**Subject: Addendum to Plume Delineation Workplan, Chevron Service Station No. 9-0338, 5500 Telegraph Avenue, Oakland, California**

**EXTENDED SITE PLAN**  
 Chevron Service Station No. 9-0338  
 5500 Telegraph Avenue  
 Oakland, California

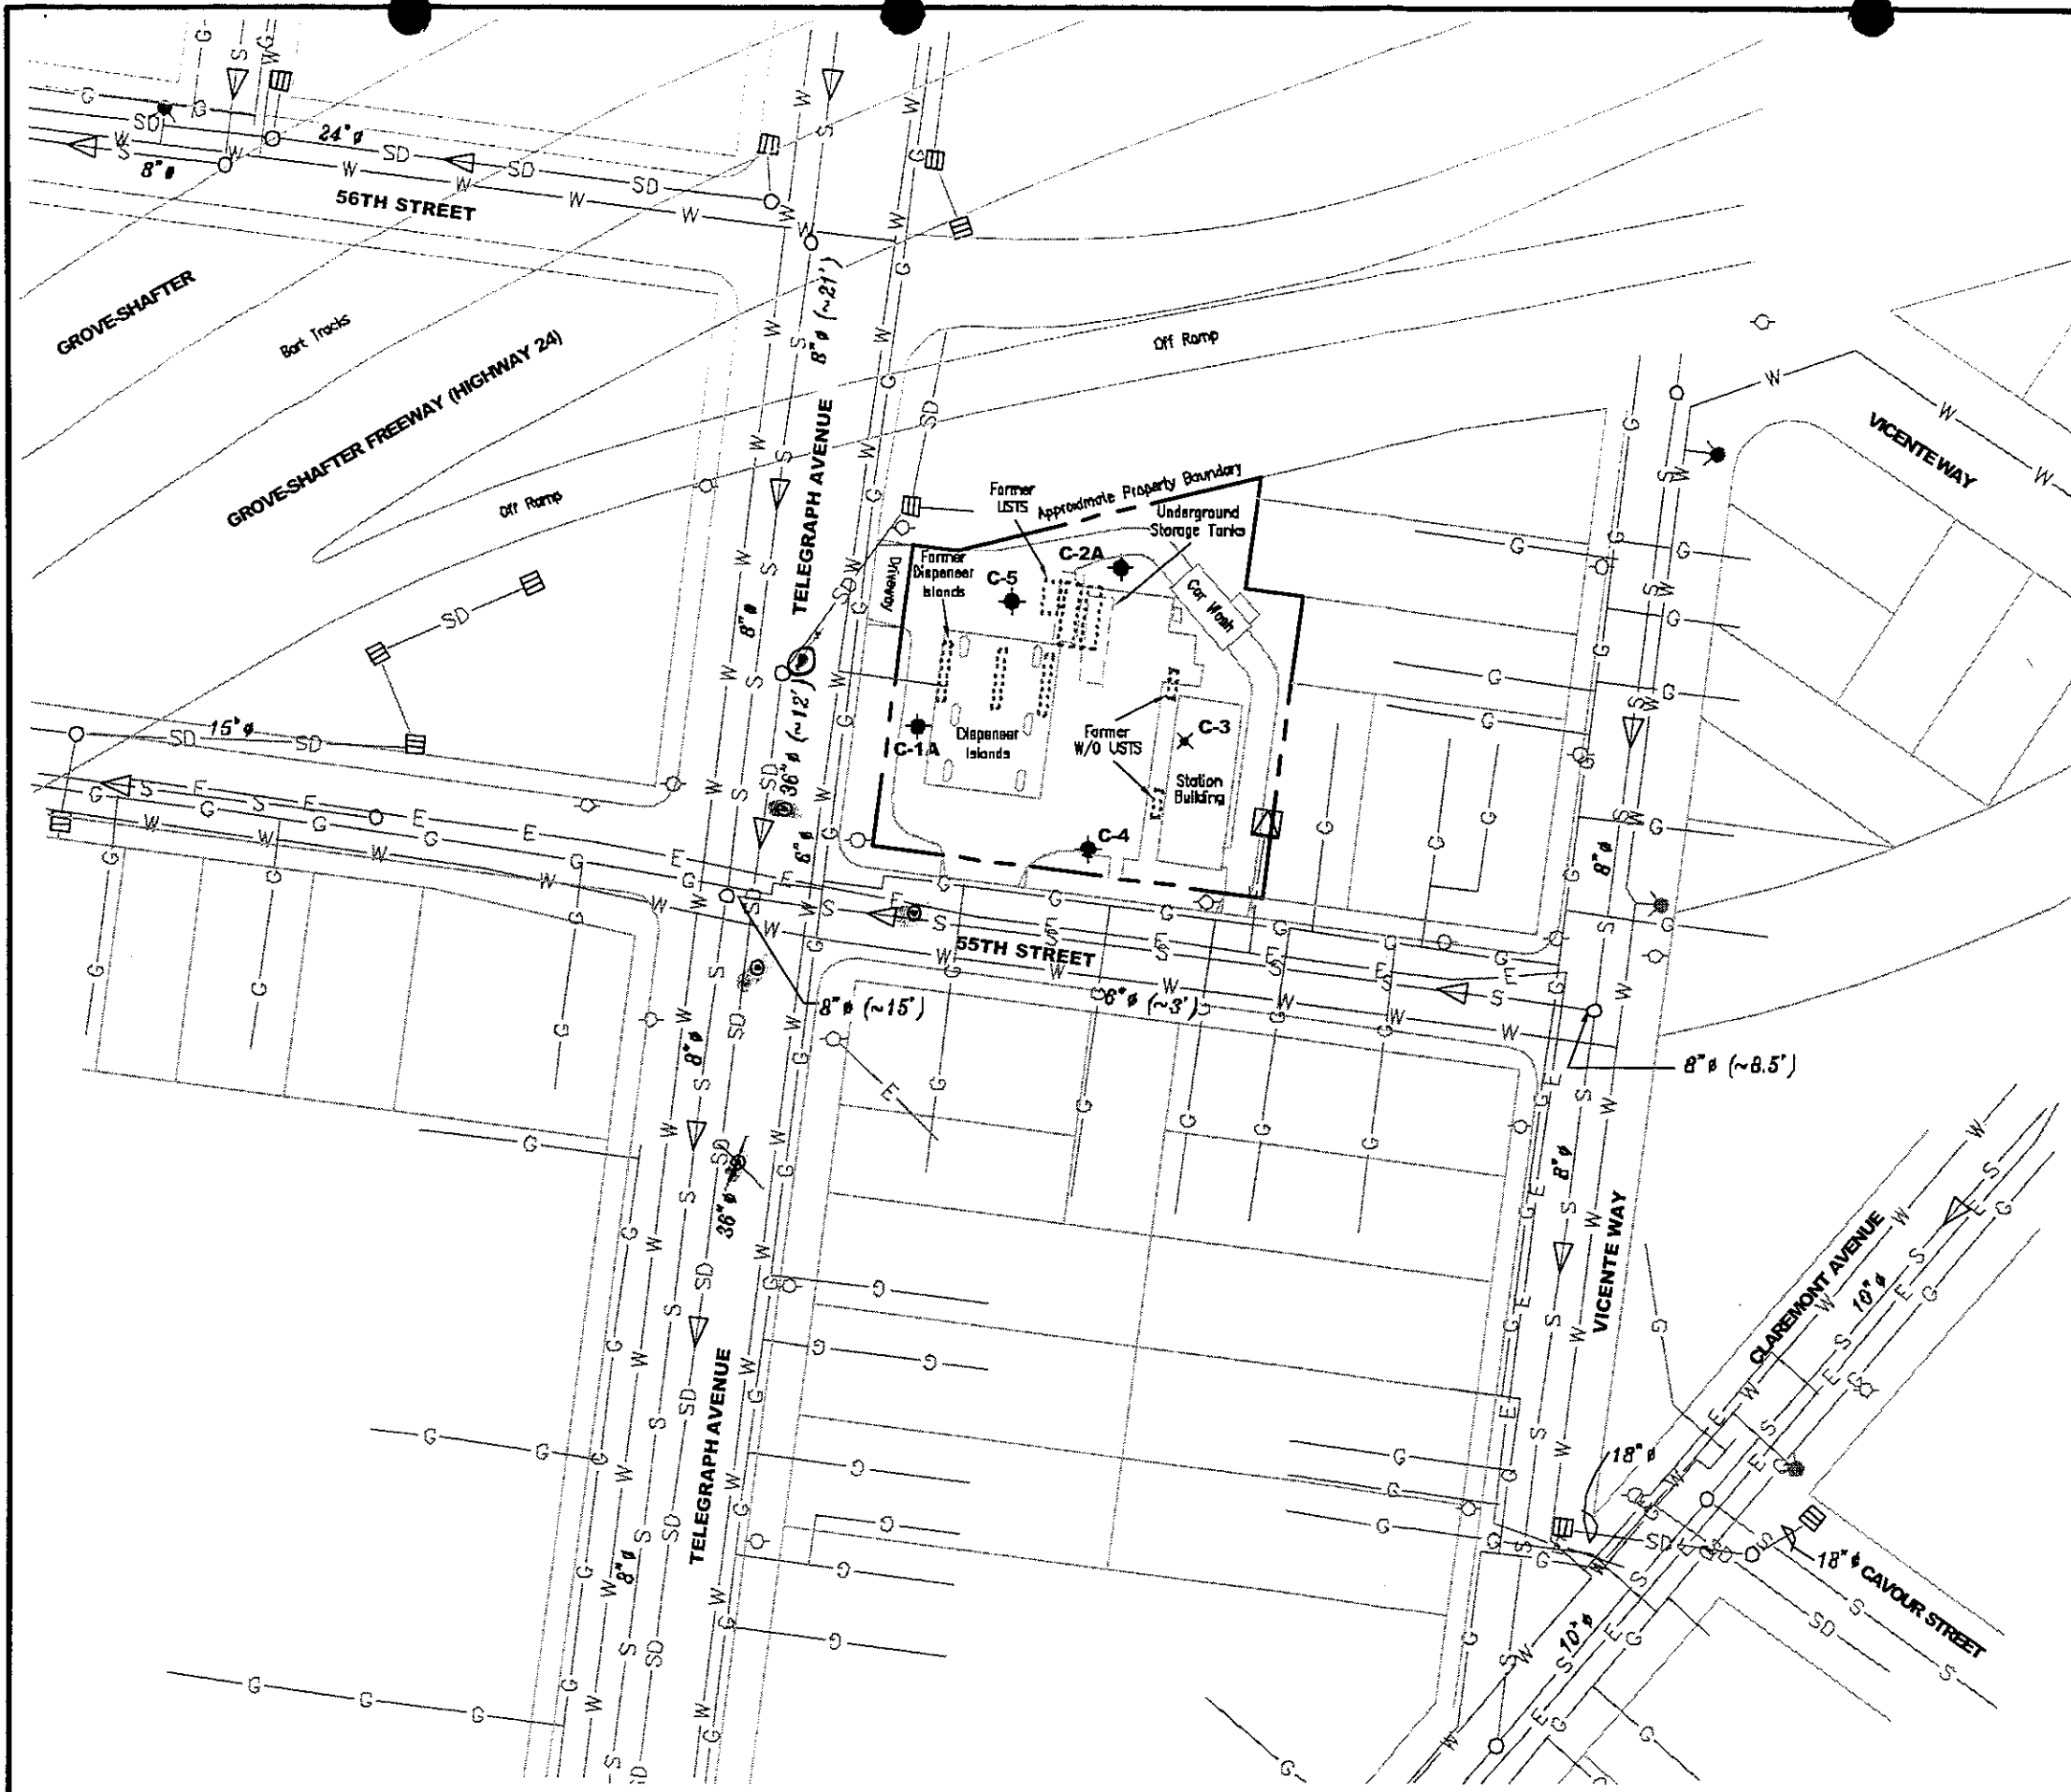
To determine whether the utility trenches are acting as preferential pathways and further delineate the petroleum hydrocarbon plume downgradient of the site, GR will advance four hand-augered soil borings to approximately 12 feet below ground surface (bgs) at the locations shown on Figure 1. The borings will be advanced by GR (C57 #220793) at locations adjacent to the storm drain line beneath Telegraph Avenue and the sanitary sewer line beneath 55<sup>th</sup> Street, as located by a private subsurface utility locating service. The borings will be advanced into the fill around the sanitary sewer and storm drain lines, and a soil sample from approximately 8 feet bgs (capillary fringe) and a grab groundwater sample will be collected from each boring. Soil and grab groundwater samples will be analyzed for Total Petroleum Hydrocarbons as gasoline (TPHg), and benzene, toluene, ethylbenzene, and xylenes (BTEX) by EPA 8015/8021 Methods. Grab groundwater samples will also be analyzed for Methyl tert-Butyl Ether (MtBE), Ethyl Tertiary Butyl Ether (ETBE), Di-isopropyl ether (DIPE), Tertiary Amyl Methyl Ether (TAME), and Tertiary Butyl Alcohol (TBA) by EPA Method 8260. Upon completion, the borings will be backfilled with compacted excavated soil and completed to surface per City of Oakland requirements.
